## Chapter 8 Responses to Comments

### 8.0 Introduction

The North Valley Regional Recycled Water Program would provide recycled wastewater from the Cities of Turlock and Modesto via the Central Valley Project's Delta-Mendota Canal to Del Puerto Water District for irrigation purposes, and would provide annual supplemental water to designated wildlife refuges for wetlands. Three action alternatives are evaluated in the Draft EIS: two alternatives would construct pipelines to convey water from the Cities to the DMC; a third alternative would continue discharges into the San Joaquin River and would use the river and expanded existing facilities for conveyance. 1-1

Figure 8-1: Difference in Temperature Downstream and Upstream of Modesto Discharge

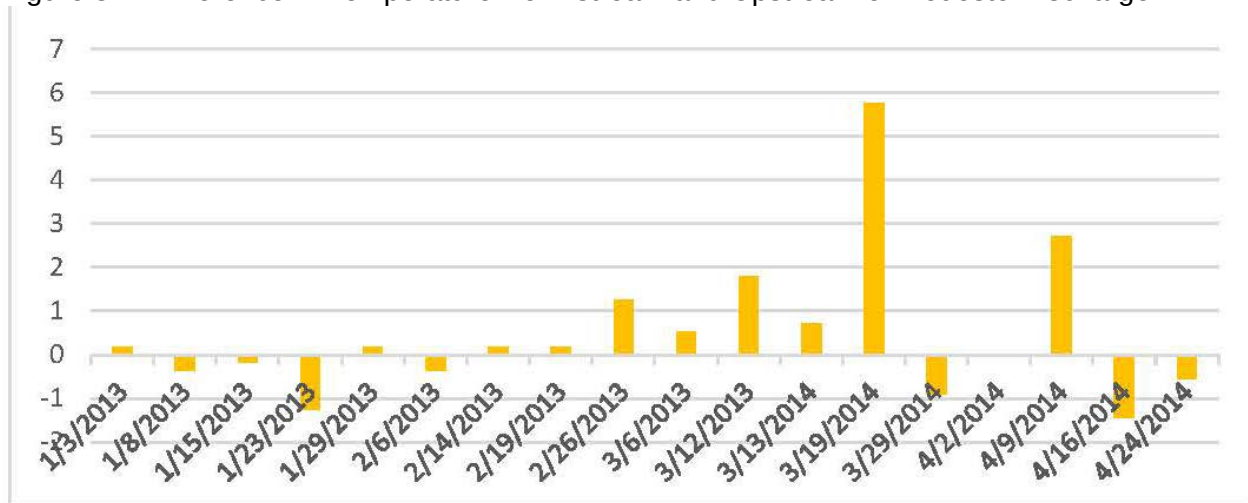
*Comment Summary: The comment states that the list of Clean Water Act 303(d) impairments needs to be updated to include temperature impairment of the San Joaquin River and include temperature in the cumulative effects analysis of reduced flows.*

During the summer months, the City of Modesto does not discharge to the river and the City of Turlock discharges effluent that is about the same temperature as the river. Turlock effluent temperature averages 25.7 degrees Celsius (°C) while the river temperature averages 25.5 °C. Both cities are allowed to discharge in the winter months, when the temperature of the river averages 12.1 °C. During winter Turlock effluent temperatures average 18.3 °C, and removing this discharge would not make the water in the river warmer.

During their discharge season the City of Modesto monitors temperature of their effluent and at upstream and downstream receiving water locations. Review of that data, which is presented in **Figure 8-1** shows that there is no predictable relationship between the temperature of the discharge and the changes in temperature downstream. In 2013, temperatures downstream of the discharge location were warmer than the upstream temperature on ten sampling dates and were colder than the upstream temperature on seven sampling dates (see chart below). On several sampling dates the discharge was warmer than the upstream receiving water temperature, but the downstream receiving water temperature was colder than the upstream temperature. Given the lack of relationship between discharge temperature and receiving water temperature, removing the discharge is not expected to increase temperatures in the river, and would thus not make a contribution to cumulative temperature effects. The minor changes in the volume of water in the river were evaluated in the Draft EIR/EIS. As noted on page 3.11-25, *“reduction in river stage height (a reflection of water depth in the river) associated with curtailment of recycled water discharges is estimated to range from 0.25 inches to 1 inch”* and this is not expected to result in a measurable change in temperature. As noted in the cumulative analysis on page 3.11-27 of the Draft EIR/EIS *“the reduction in San Joaquin River stream flows at Vernalis due to NVRRWP is approximately 0.5 percent of the average annual flows (Appendix G: Evaluation of NVRRWP Impact on Groundwater, 2014). This is considered to be a less than significant impact. The C2Vsim model that was used to estimate changes in San Joaquin River flows considers cumulative impacts of multiple environmental factors.”* Because the change in flows is considered minimal on a cumulative basis, the small changes in flows is not expected to result in a cumulative effect on temperature.

Figure 1. Turlock Groundwater Basin Location and Boundaries

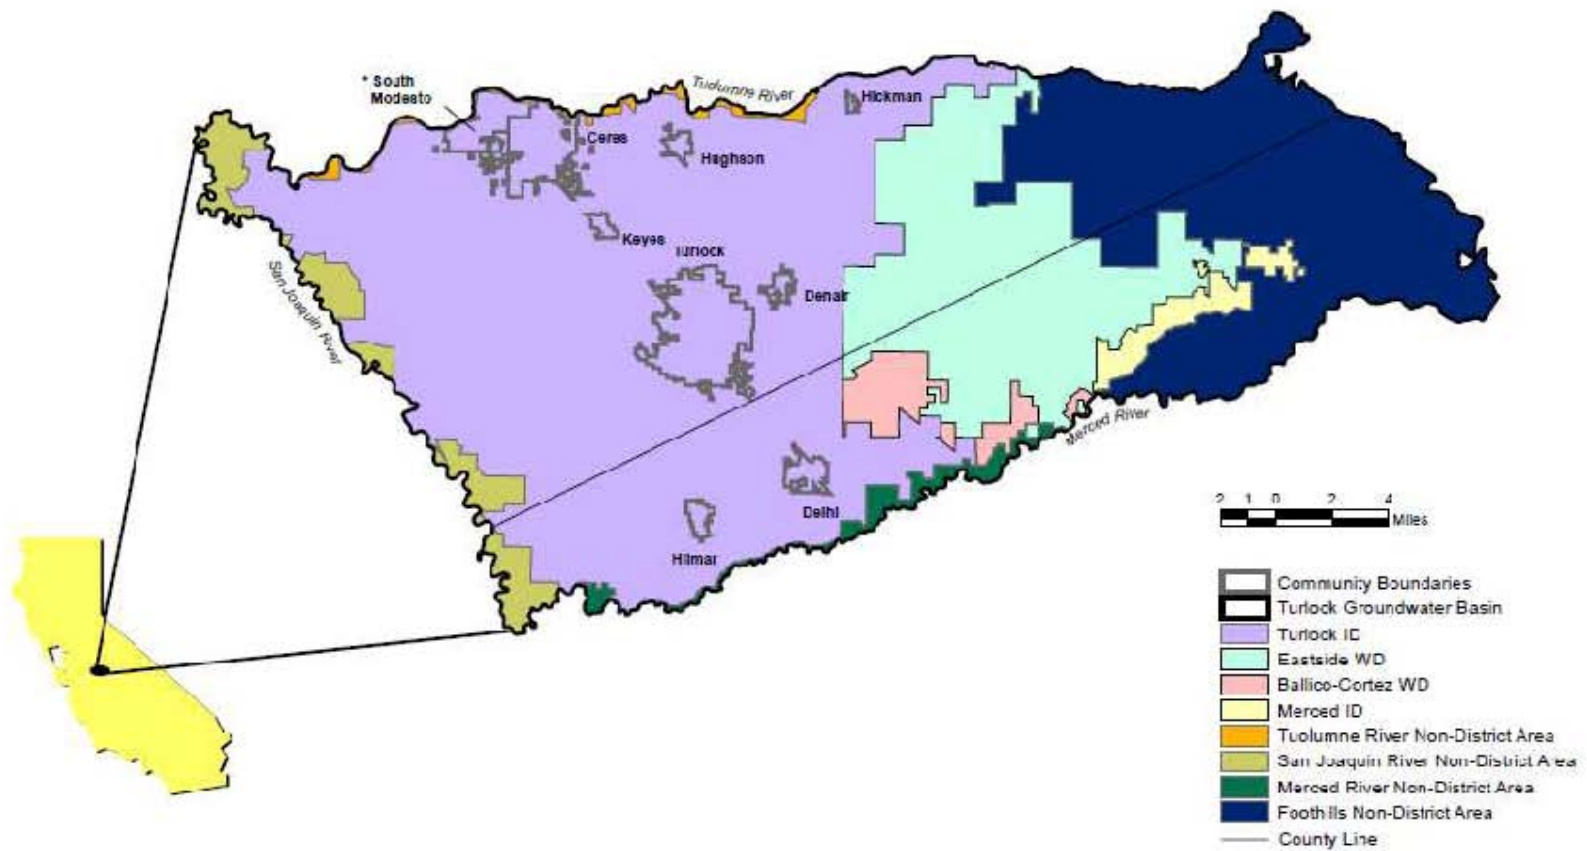
8-17 The Turlock Subbasin is described in the 2008 Turlock Groundwater Basin Groundwater Management Plan ("GWMP"). The GWMP was adopted by TID on March 18, 2008 and by the City of Turlock on Feb. 26, 2008. Figures 1, 5 and 6 of the GWMP shows the location, boundaries, and characteristics of the Turlock Subbasin and are attached for reference (Attachments 1, 2 and 3, respectively). The Subbasin is bounded by the Tuolumne River on the north, the Merced River on the south, the San Joaquin River on the west, and on the east by the western extent of the outcrop of crystalline basement rock in the foothills of the Sierra Nevada Mountains. The City of Turlock, the City of Ceres, the portion of the City of Modesto located south of the Tuolumne River ("South Modesto"), and the communities of Denair and Keyes are all within this Subbasin and within TID's irrigation boundaries. As of 2008, the Subbasin underlies an area of approximately 347,000 acres, with irrigated crops (245,000 acres), native
